2009 Fall Revision Cycle

Report on Proposals

A compilation of NFPA® Technical Committee Reports on Proposals for public review and comment

Figure A.7.9.3

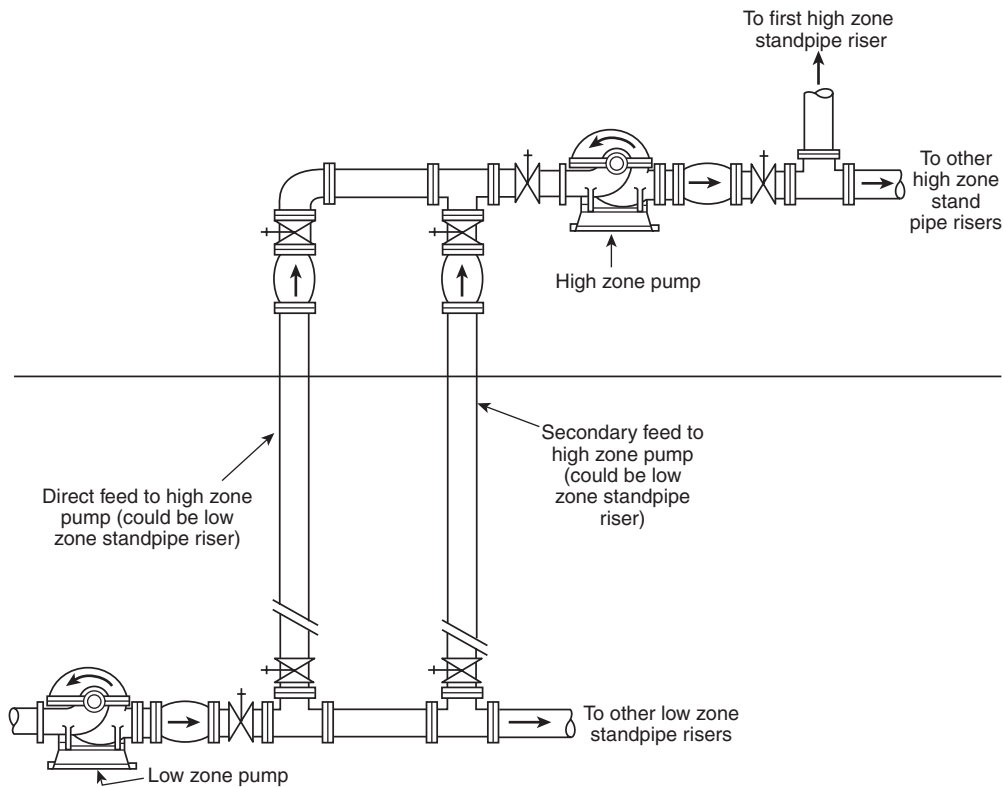
A.7.9.3 See Figure A.7.9.3

Revise sections in the existing 7.9.3 as follows:

Figure A.7.10.1.2.1.1

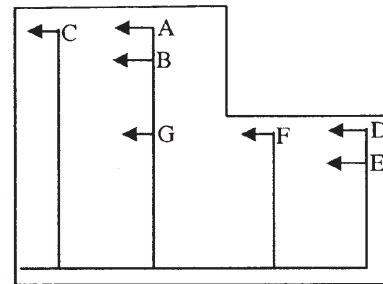
A.7.10.1.2.1.1 For example, consider the standpipe system shown in Figure A.7.10.1.2.1.1 with two risers that terminate at the 15th floor and two risers that terminate at the 10th floor of this fully sprinklered high-rise building. In this case, two separate hydraulic calculations need to be performed. The first would verify that the system can deliver 100 psi to the top of the risers on the 15th floor with a total of 750 gpm flowing (250 gpm each at points A, B and C). The second would need to prove that the system can deliver 100 psi to the 10th floor with a total of 1000 gpm flowing (250 gpm each at points D, E, F and G). Note that since the building is sprinklered, there is no flow required from the fourth riser in this second calculation.

Recommendation: Add new text as follows:

Where standpipes terminate at a level lower than roof level, they shall not be required to be calculated with the topmost outlets. Additional calculations shall be provided at the lower level.

A.
Proposed Figure 7.2.2 (Attachment)

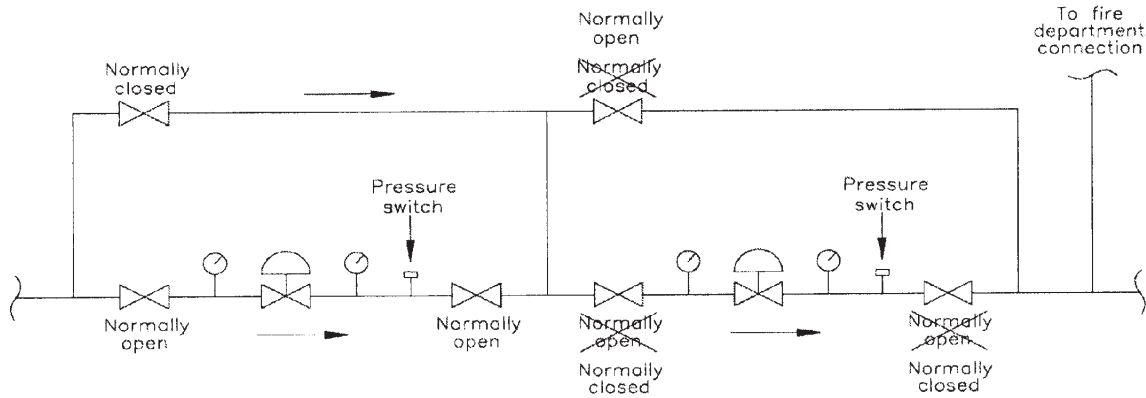
Submitter: Stephen M. Leyton, Protection Design and Consulting
Recommendation: Delete Figure A.7.2.2(a).

Revise Figure A.7.2.2(b) as shown.

Substantiation: There is no reasonable application for Figure A.7.2.2 (a), where a bypass would be required or furnished around a single Pressure Reducing Valve.

As shown, Figure A.7.2.2 (b) would direct water through both Pressure Reducing Valves, creating a redundant pressure reduction that would cause different outlet pressures in case of failure. The intent of the redundancy is to have a (redundant) backup valve, not a two-stage design. The inlet valve on the second PRV should be normally closed. The second valve on the bypass should be normally open.

The deletion of Figure A.7.2.2(a) is accepted, the revision to Figure A.7.2.2(b) is not accepted.

Committee Statement: The committee accepts the deletion of Figure A.7.2.2(a) as it concurs with the submitter that this arrangement should not be used. The revision to Figure A.7.2.2(b) is not accepted because such an arrangement could cause the system piping downstream of these devices to be exposed to excessive pressure should the first valve fail in the open position.

Figure A.7.3.2(d)

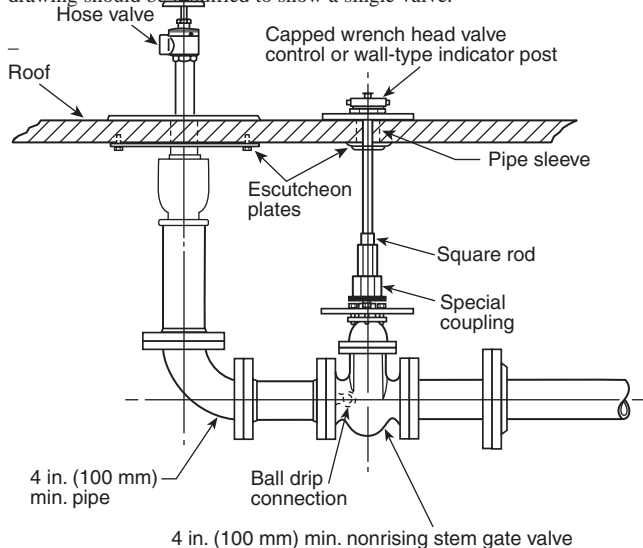
Submitter: Technical Committee on Standpipes,
Recommendation: Revise Figure A.7.3.2(d) Roof Outlet Piping Arrangement as shown below;

CONWAY, B.: During the committee meeting, we agreed to eliminate the pipe sizes shown on Figure a.7.3.2.D. also, the committee clarified that two valves are not required for testing per proposal 14-100 (log #71), so the

drawing should be modified to show a single valve.
